ADDENDUM  
NO. 02

**Kalamazoo Public Schools Chenery Auditorium Lighting Replacement**  
**714 South Westnedge Avenue**  
**Kalamazoo, MI 4900**

## ADDENDUM NO. 2

DATE OF ISSUANCE:	January 27, 2026, 2026
PROJECT:	CEC – Chenery Auditorium Lighting Replacement 714 South Westnedge Avenue Kalamazoo, MI 49024
OWNER:	Kalamazoo Public Schools
ARCHITECT'S PROJECT NO.:	23-644.00
ORIGINAL BID ISSUE DATE:	January 8, 2026

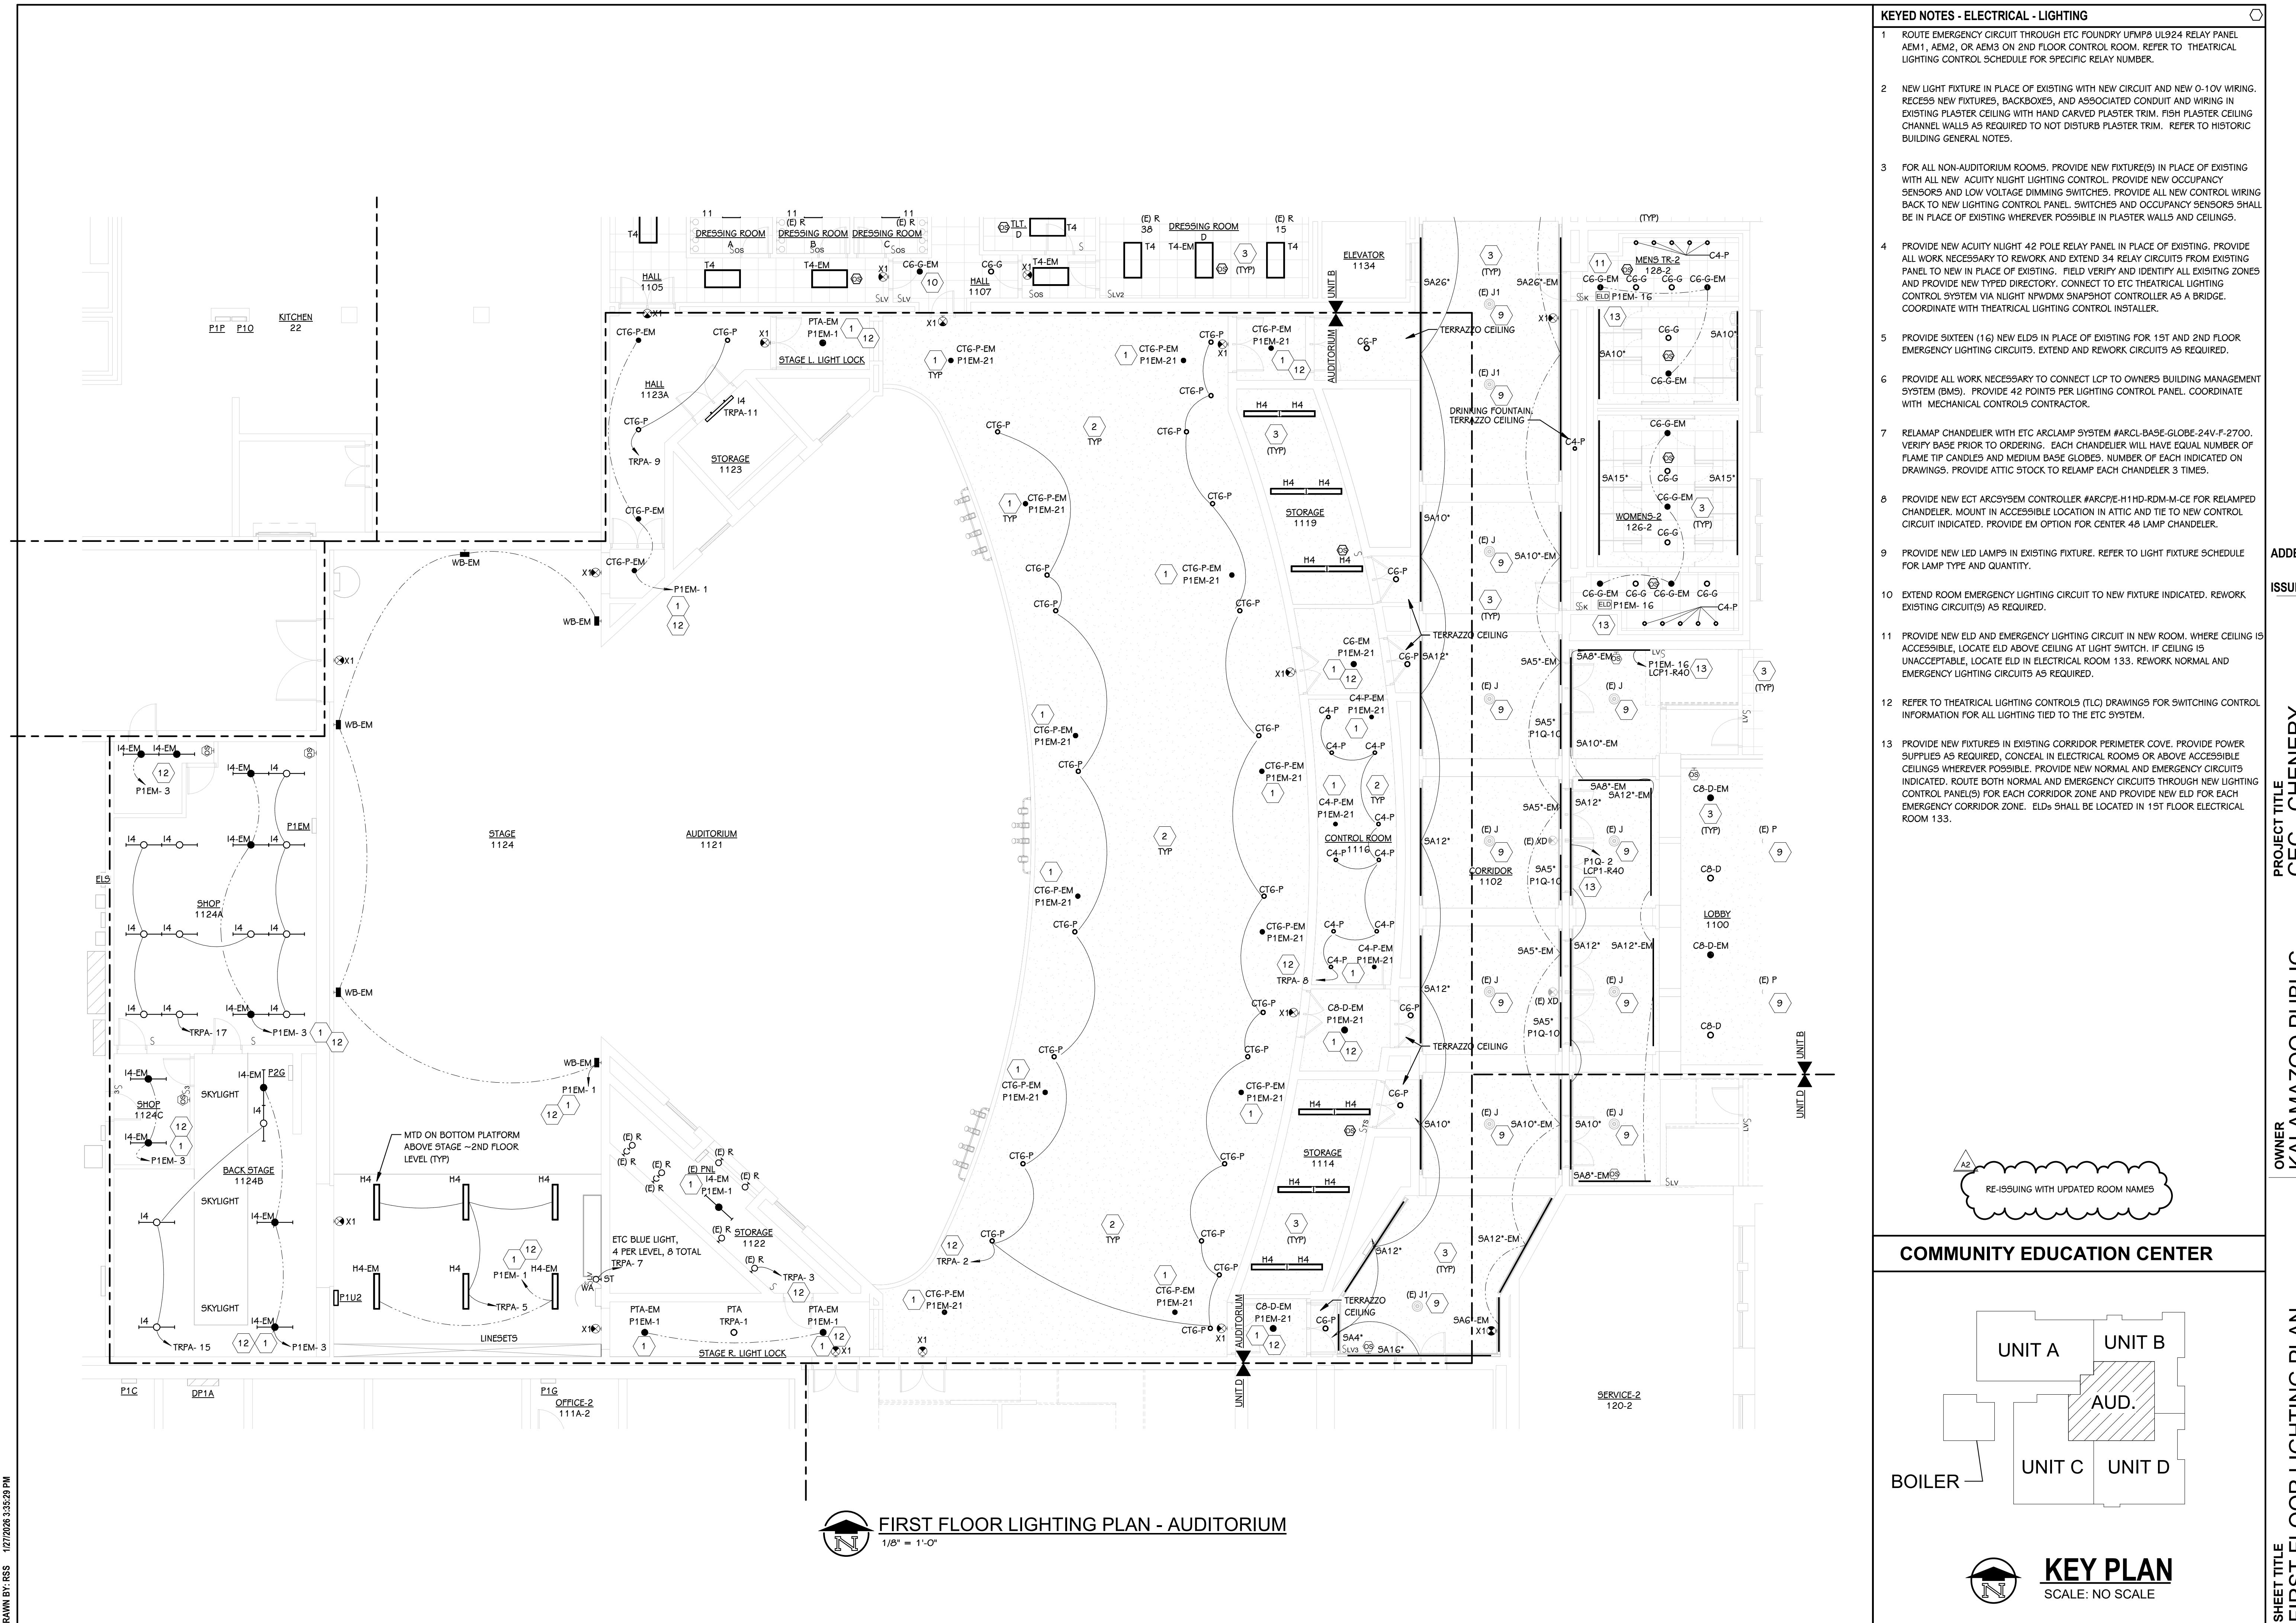
Refer to Sheet[s]: E-201.A

Updated space names.

SHEET NUMBER  
E 412  
23644.00

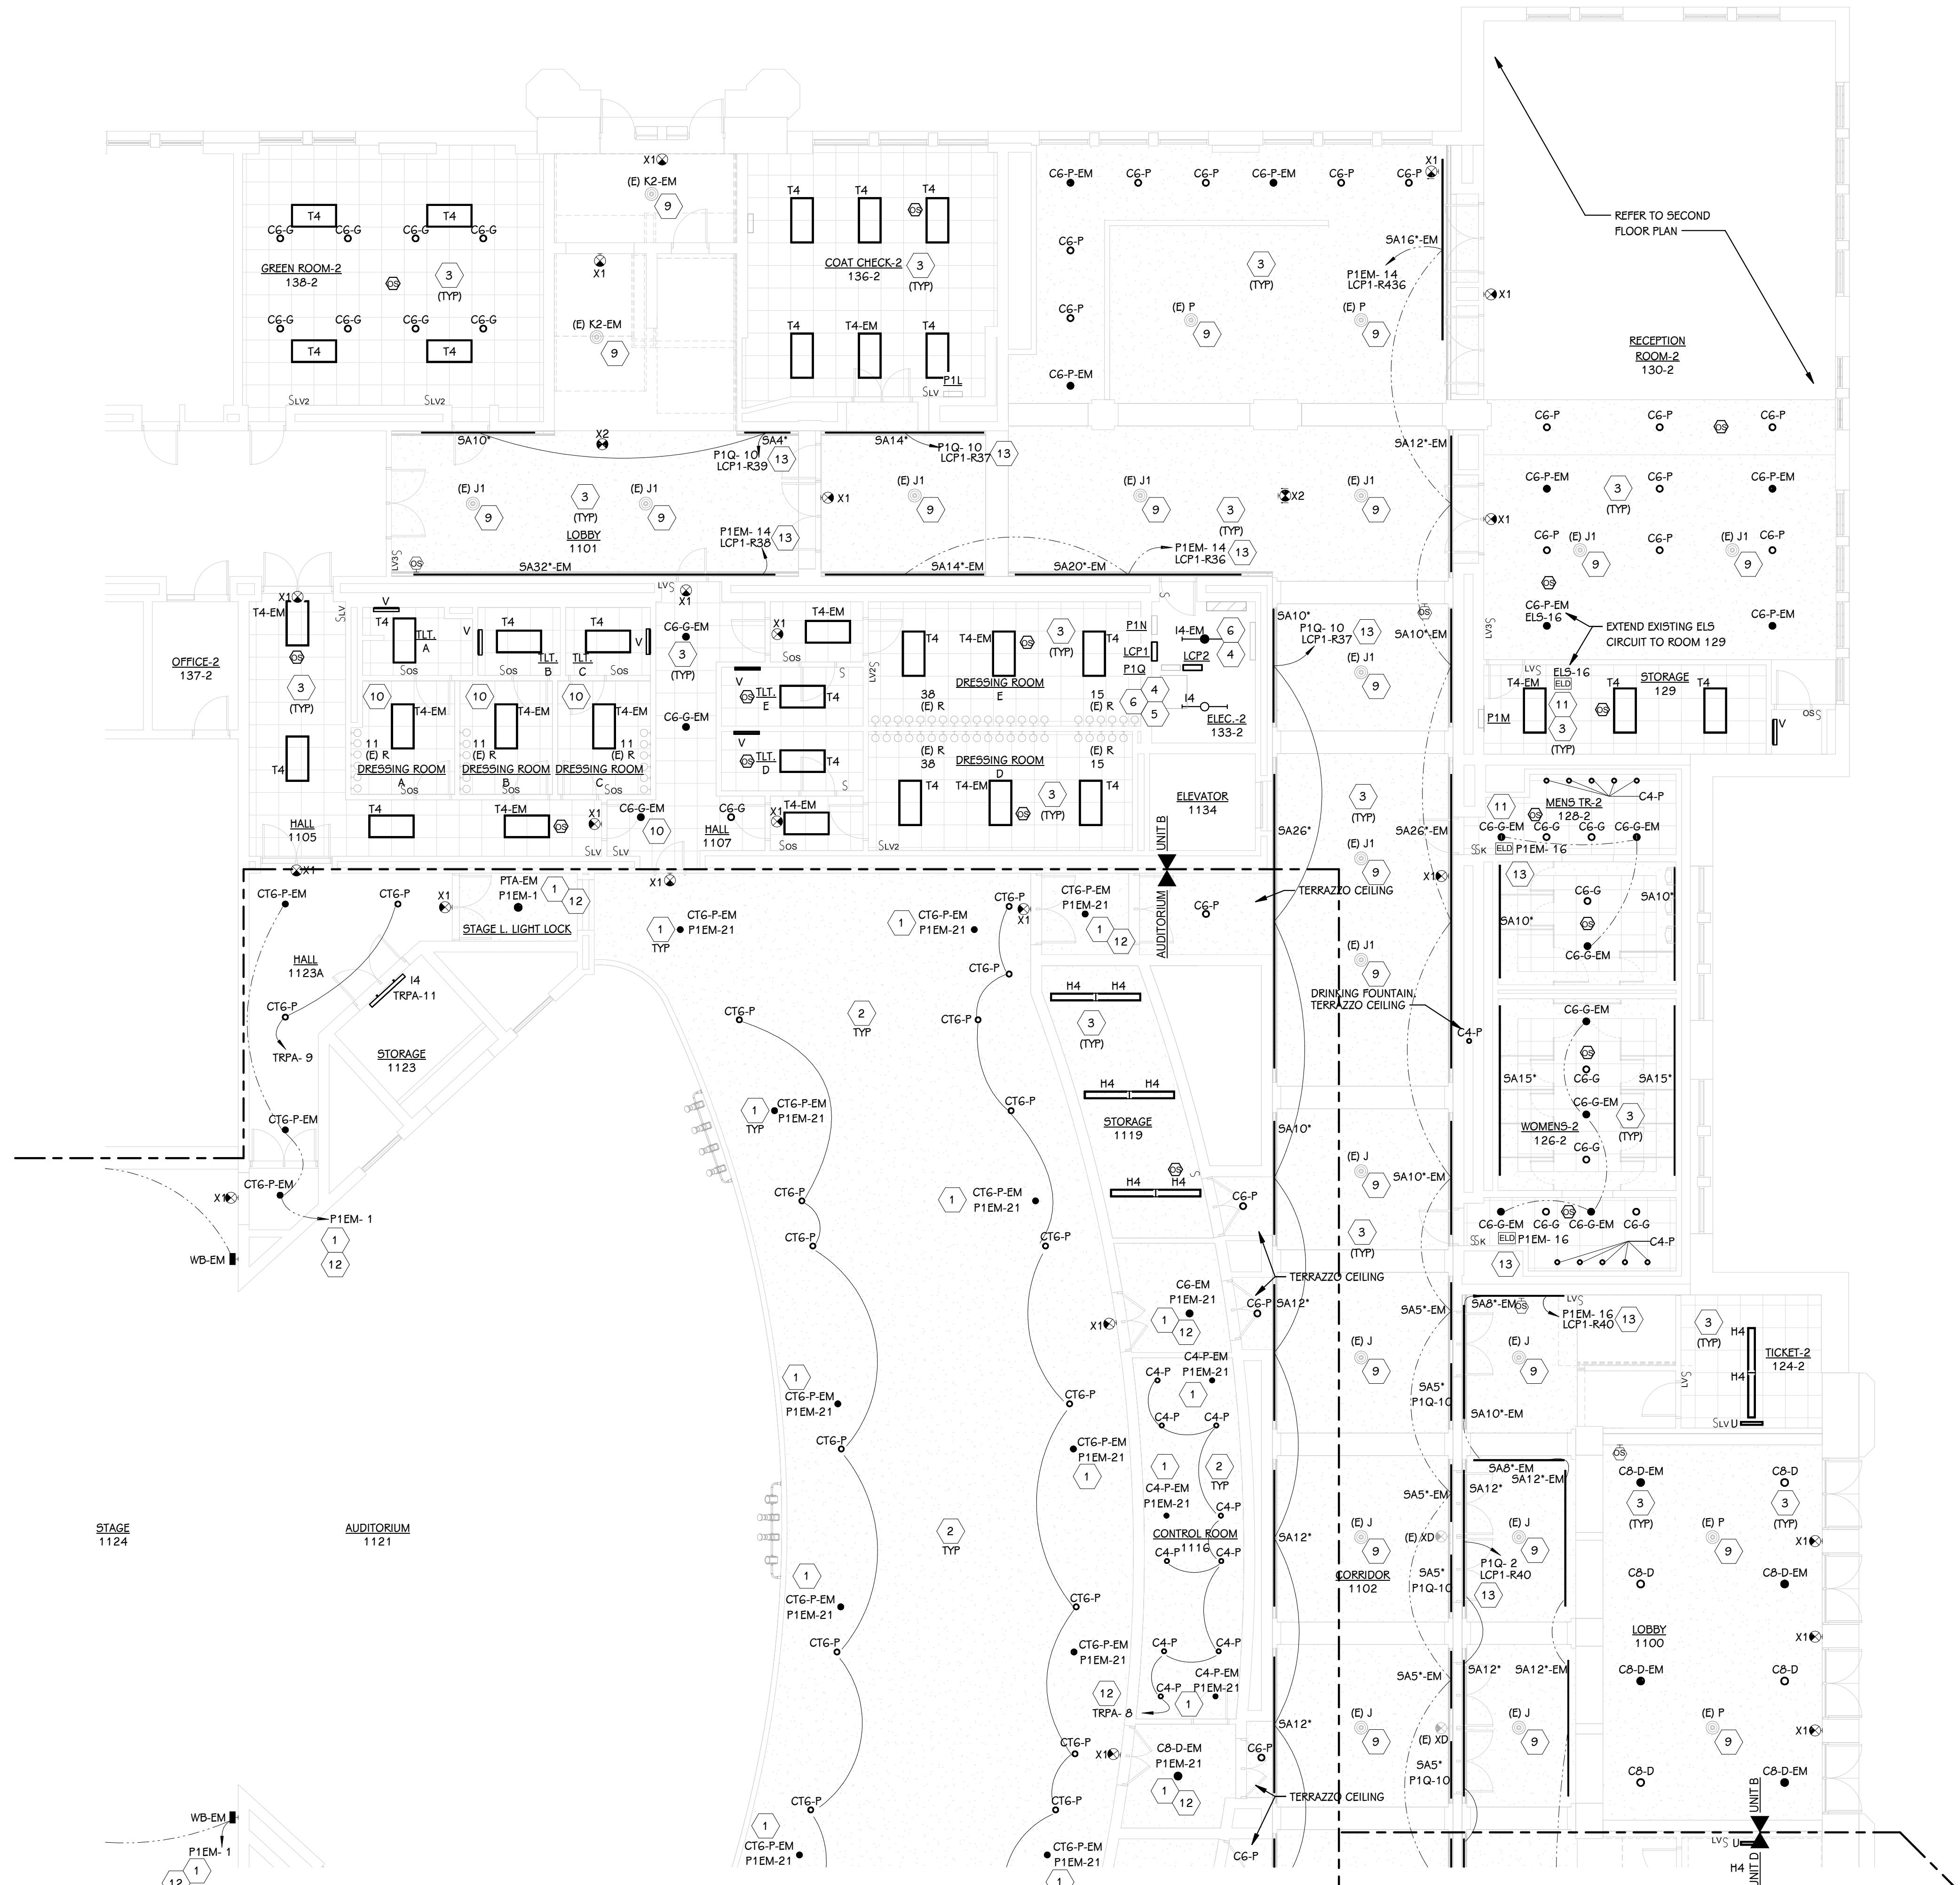
**ADD-2 Item No. D-5 - Lighting Control Schedule**

Refer to Sheet[s]: E-412

Provided lighting control schedule.

SECOND FLOOR LIGHTING PLAN - AUDITORIUM  
1/8" = 1'-0"

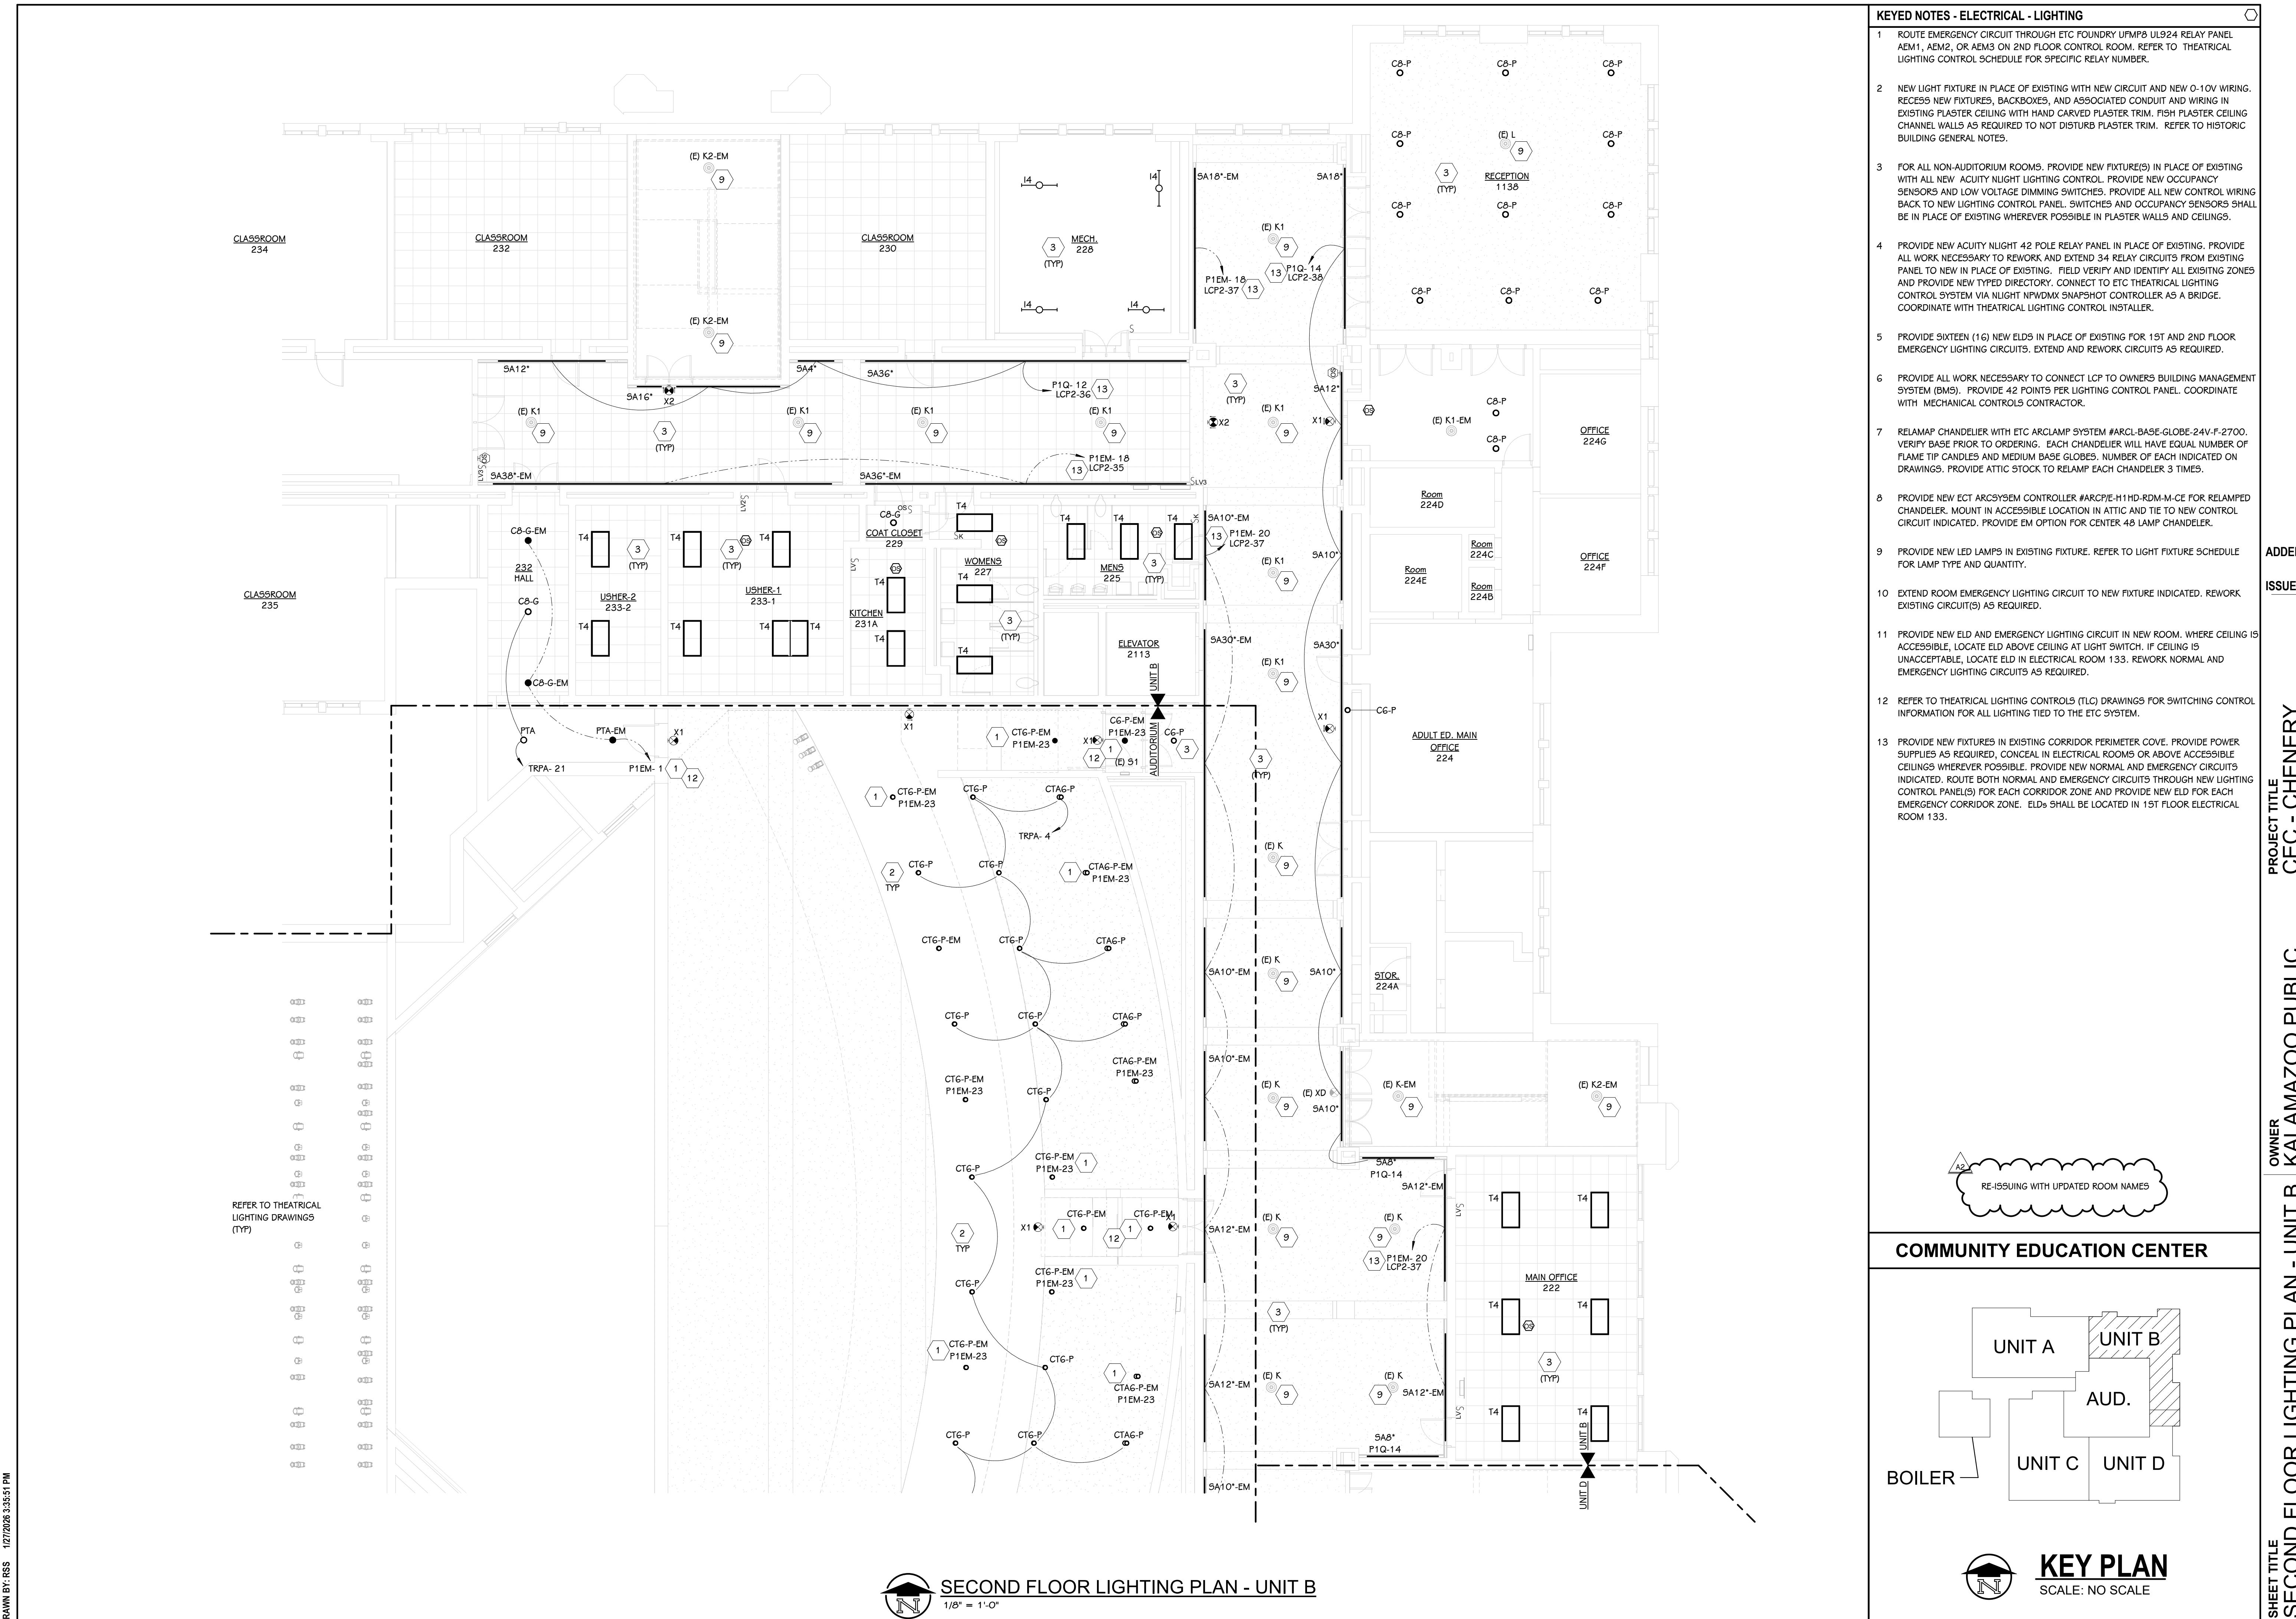
Refer to Sheet[s]: E-202.A

Updated space names.
